OREGON PARKS & RECREATION DEPARTMENT  
5330 Seaman Road  
Oregon, Ohio 43616  
(419) 698-7145  
FAX (419) 698-7086

**ADDENDUM No. 1**  
**Recreation Buildings - 2023**

Plan holders of the Recreation Buildings - 2023 Project are hereby notified of the following amendments to the Contract Documents. The following additions, alterations, deletions and/or clarifications shall be part of the bid specifications as much as if they were originally included in the Contract Documents. This Addendum No. 1 is hereby made a part of the Contract Documents and must be receipted for on the proposal form.

MISCELLANEOUS PROJECTS  
FOR  
CITY OF OREGON  
RECREATIONAL DEPARTMENT  
GON,

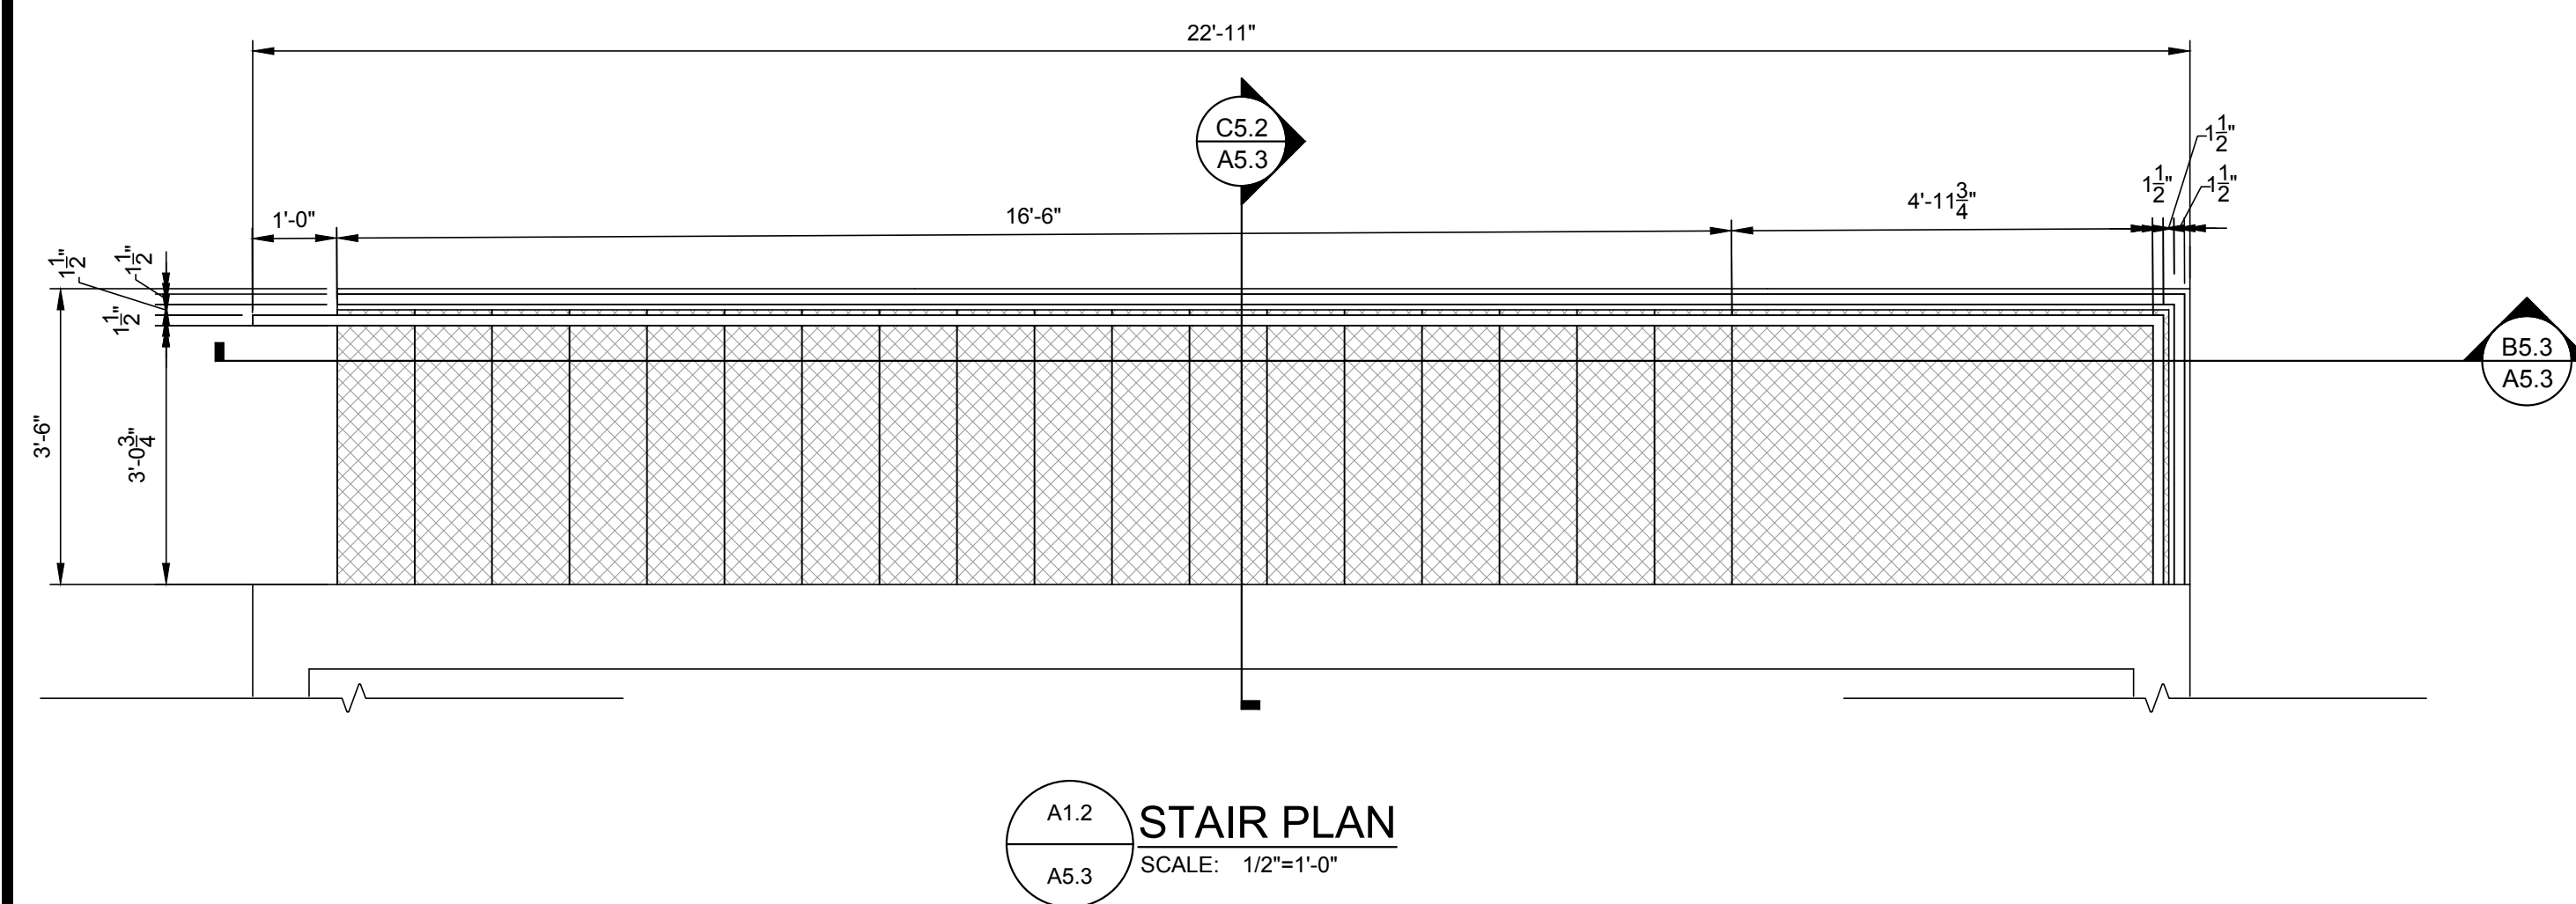
- 13) **Bidder Question:** *Regarding the stairs to the Pressbox: Drawing S2.2 calls for Welded Bar Grating as the walking surface, A5.3 calls for traction treads. Please confirm which is correct.*

- 14) **Bidder Question:** *Please provide additional details on the cable railing?*

**Architect/Engineer Response:** Welded bar grating is correct. Drawing A5.3 was corrected to match S2.2.

**Architect/Engineer Response:** New cable railing specification was added. Railing details can be found on sheet A5.3.

A7.1

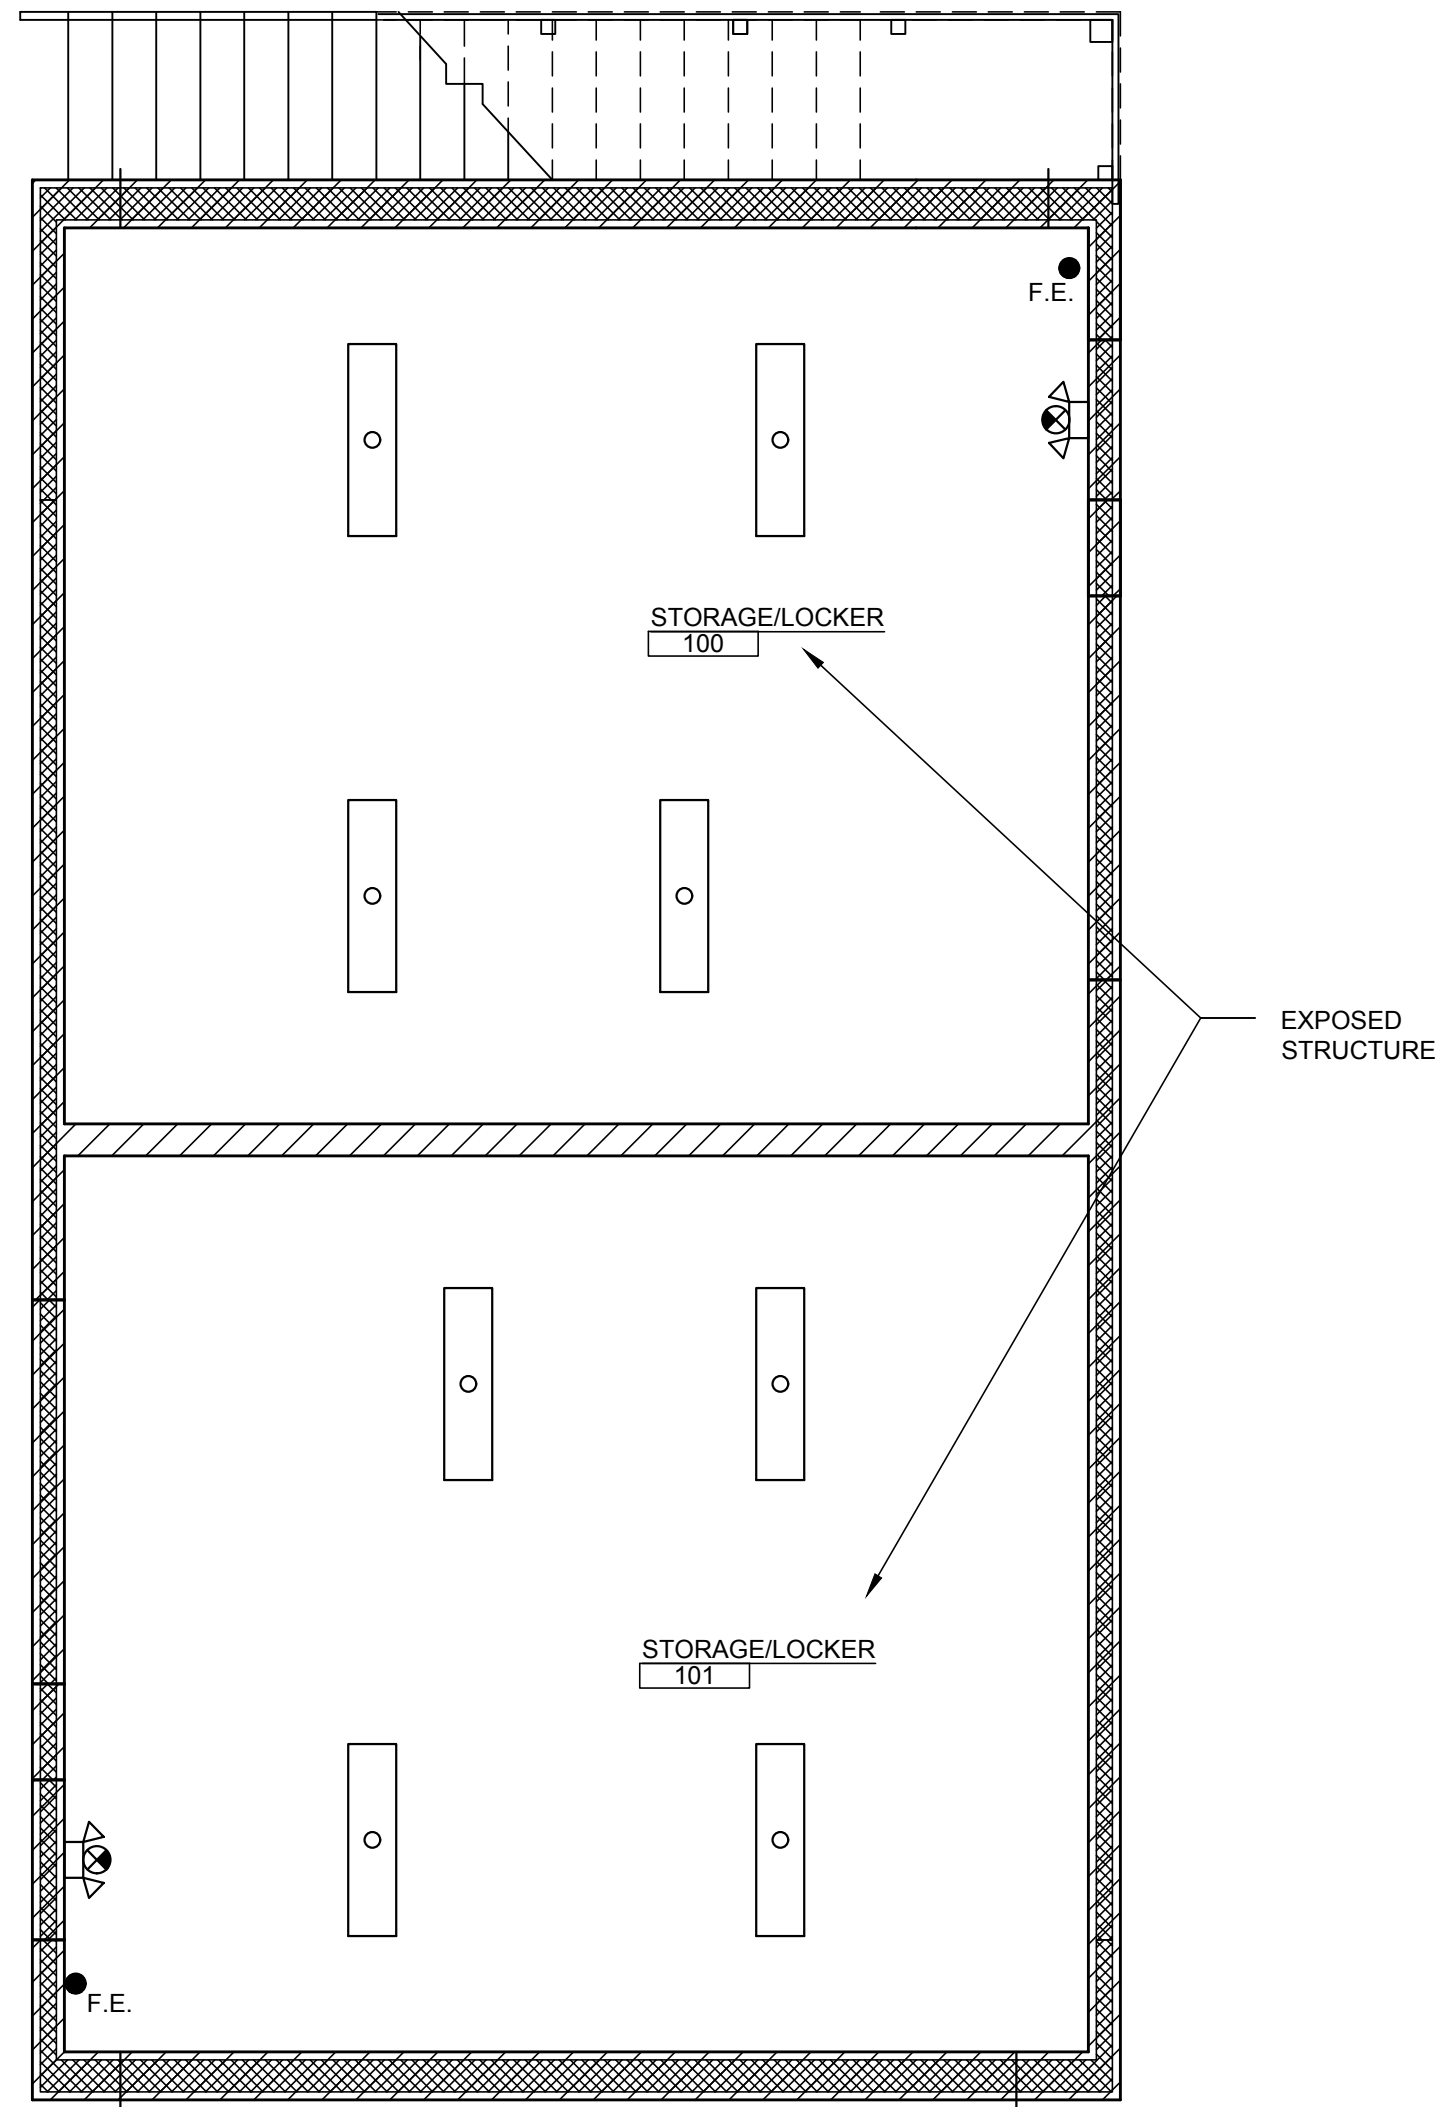
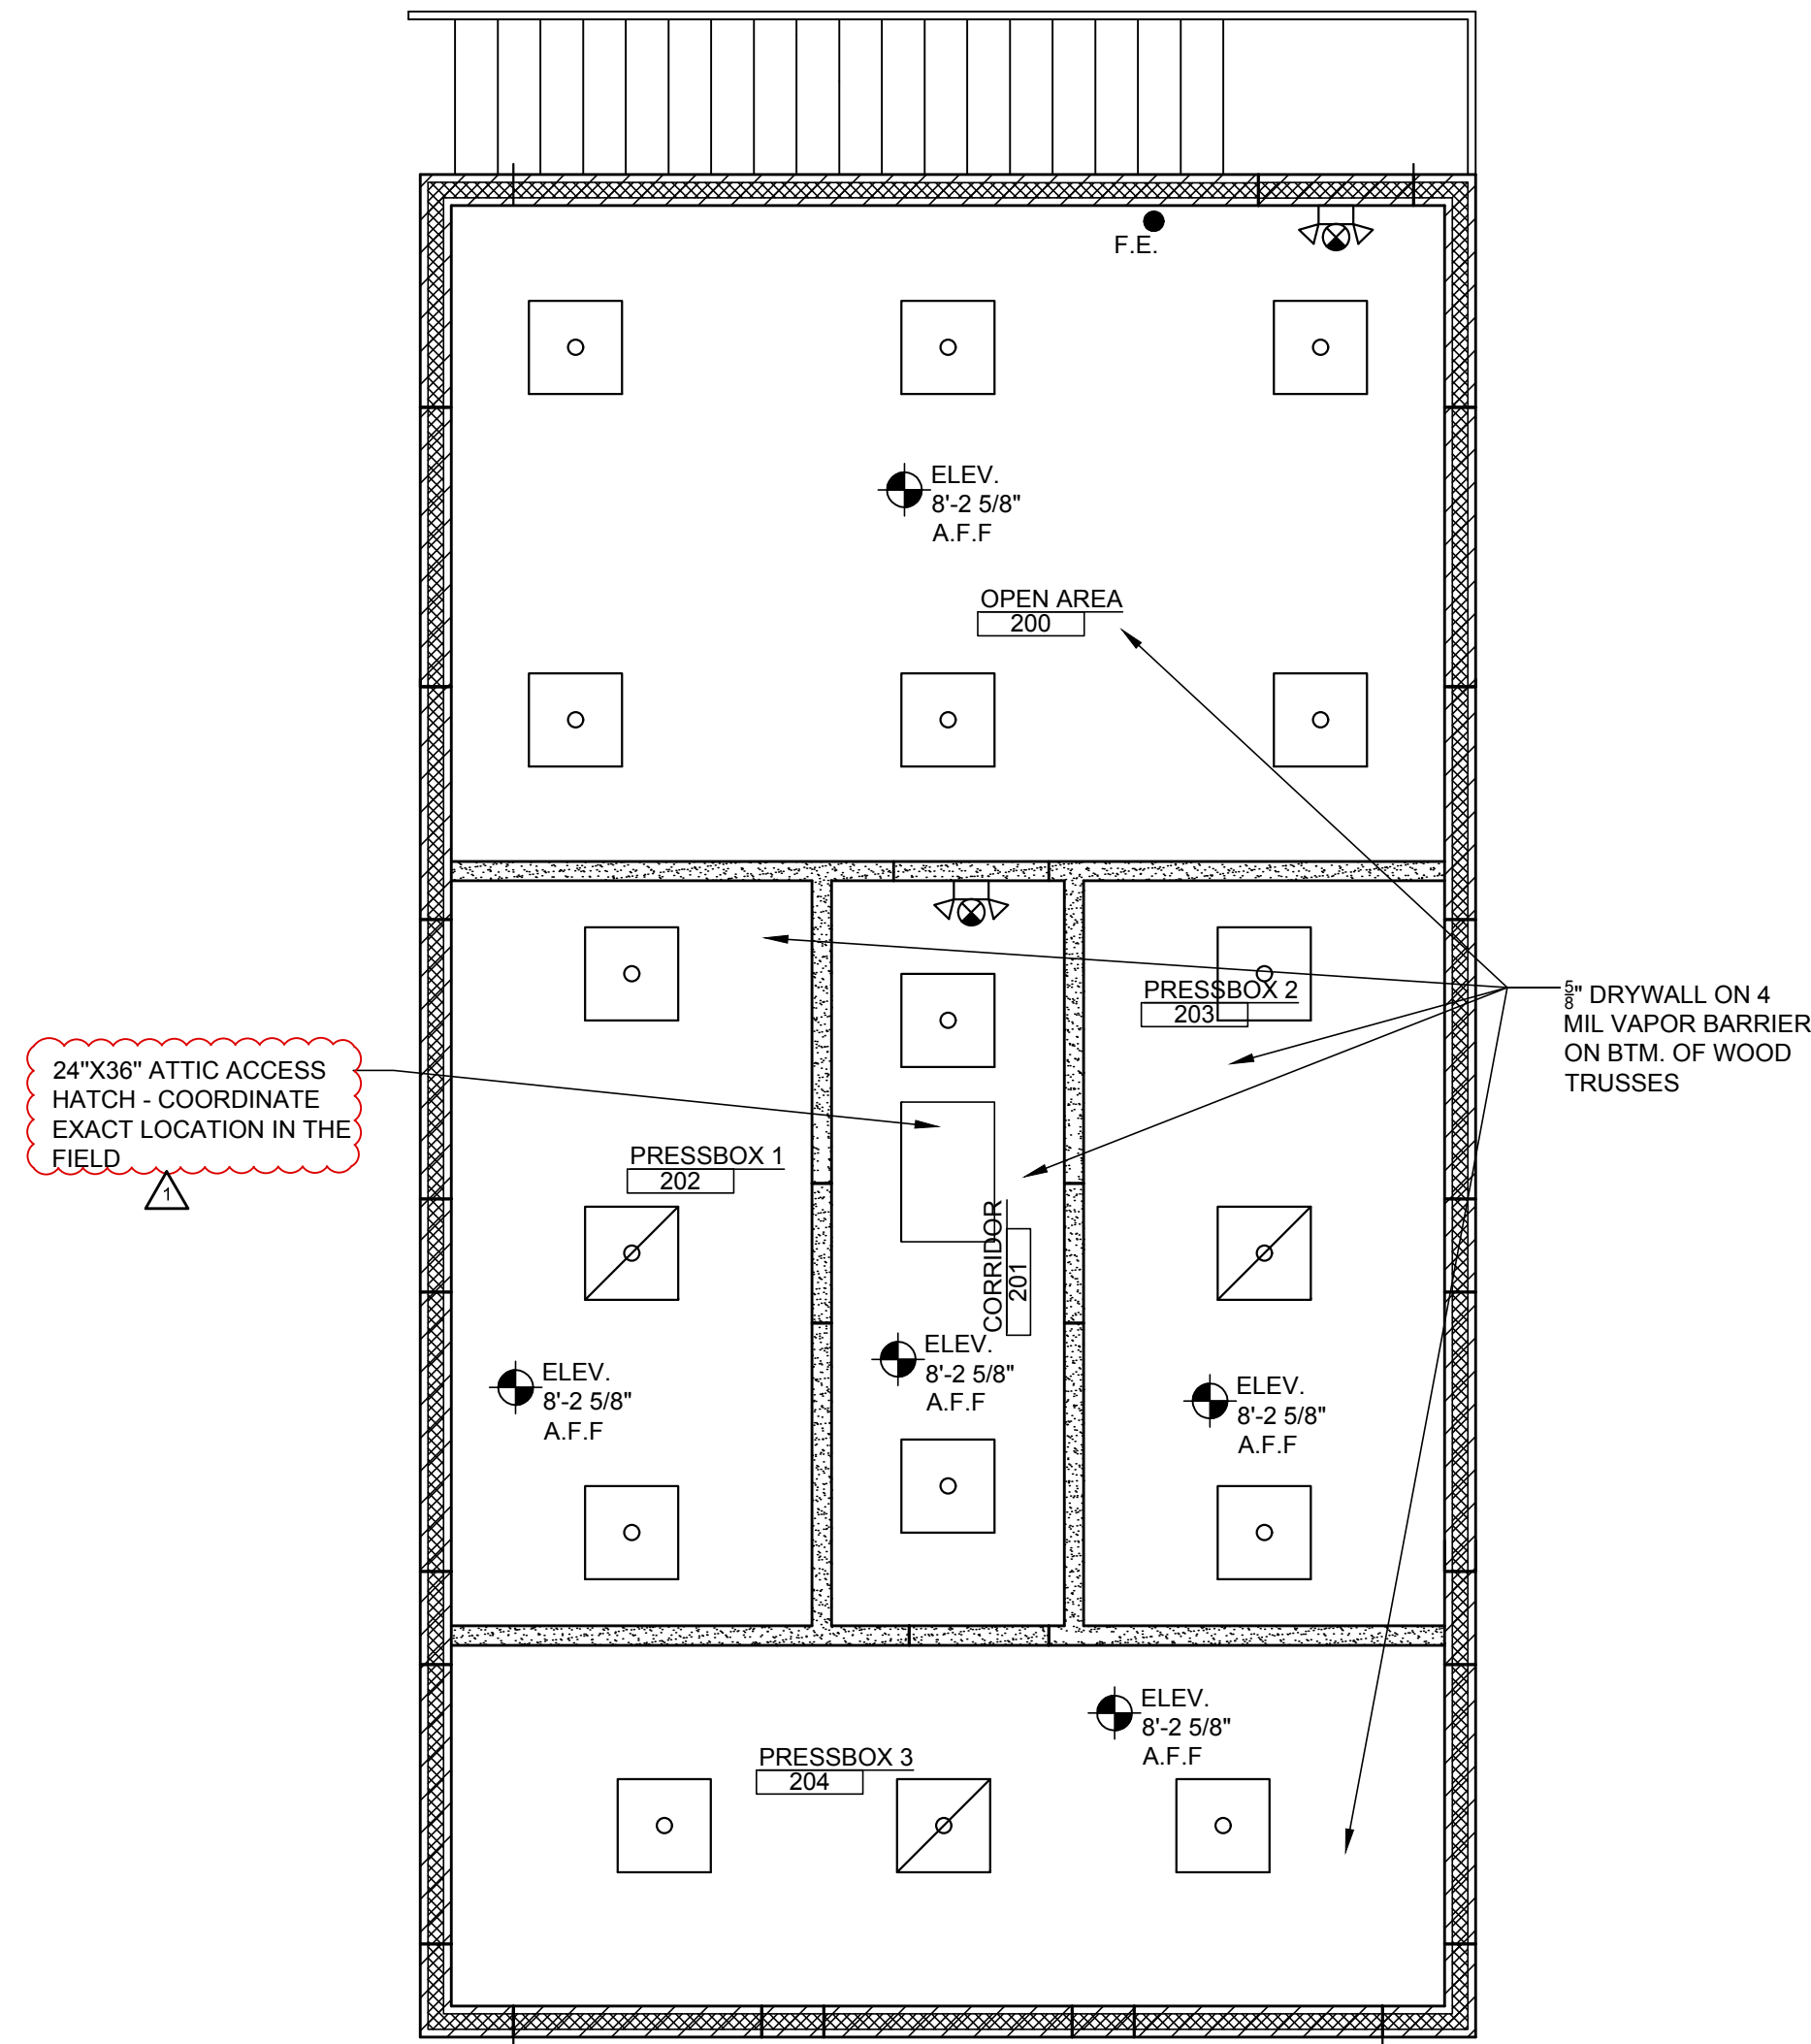
- 10) **Bidder Question:** *If the fixtures are to be changed to surface mount. This will ultimately add a lot of access holes for all the trades. Is there a specific access cover that is required?*

**Architect/Engineer Response:** The lights will be surface mounted. Access will be in the attic. Provide attic access doors as shown on the attached revised drawings A7.1 and A7.2. The access door can be found in specification section 09 21 16. Note the section was changed in this addendum, see note above.
